## **Landscape Observations for 2024/0447/01/DET**

Date 13 February 2025

Proposal: Erection of Battery Energy Storage facility with associated plant and equipment and supporting works including installation of retaining walls, boundary treatment, drainage and landscaping and relocation of substation following demolition of existing buildings on site.

*Fig5 358 mesh potential alternative to palisade fencing*

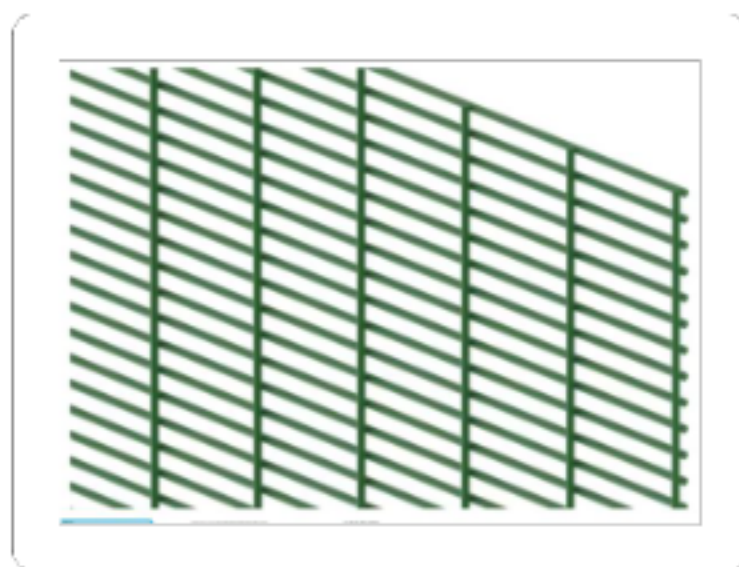
The green palisade security fence indicated on the drawings is not appropriate for the setting. If a high security fence is required, a 358 'prison mesh' type fence may be less intrusive. The fencing will need supplementing with soft landscaping, but the detail provided for a green boundary appears impractical, particularly as the ground conditions are not detailed. The height of the screen must have potential to grow to a height that breaks the skyline above the overhead plant
